80960SA/SB SPECIFICATION UPDATE

Release Date: August, 2004

Order Number: 272850-003

Figure 1. Block Diagram of Workaround

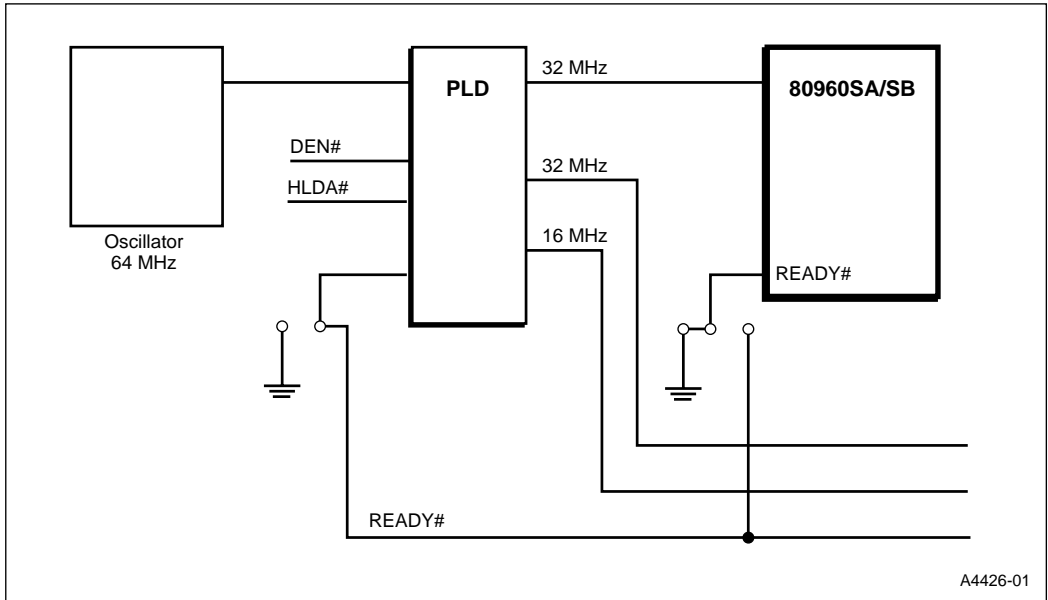
1. *Byte Enables Switch Prematurely with Wait States*

PROBLEM: During many accesses with wait states, the BE1:0# signals incorrectly switch after the first Tw state. The affected accesses include:

- All byte accesses with wait states.
- All quad-word, triple-word, long-word, word or short-word accesses with single-byte misalignment and wait states.

If the bus cycle is a burst access, the problem occurs on each data transfer within the burst. This problem will not occur if READY# always goes active early enough to signal zero wait states.

WORKAROUND: Do not use the READY# input; tie it to a LOW logic state. If wait states are necessary, gate the input clock using external logic.

Figure 1 illustrates example workaround logic. A programmable logic device (PLD) driven by a 4X clock oscillator provides a 2X clock for the 80960SA/SB and other system clocks. READY# is an input to the PLD which stops the 2X clock whenever it is asserted. When READY# is deasserted, the PLD resynchronizes the 2X clock to the system clocks. Figure 2 is a state diagram of the workaround.

The 80960SA/SB has dynamic registers, so do not stop its input clock for more than about one microsecond. This restriction limits the number of wait states to about nine for a 10 MHz 80960SA/SB.

The workaround also reduces the overall performance of the microprocessor since it cannot execute instructions while its clock is stopped.
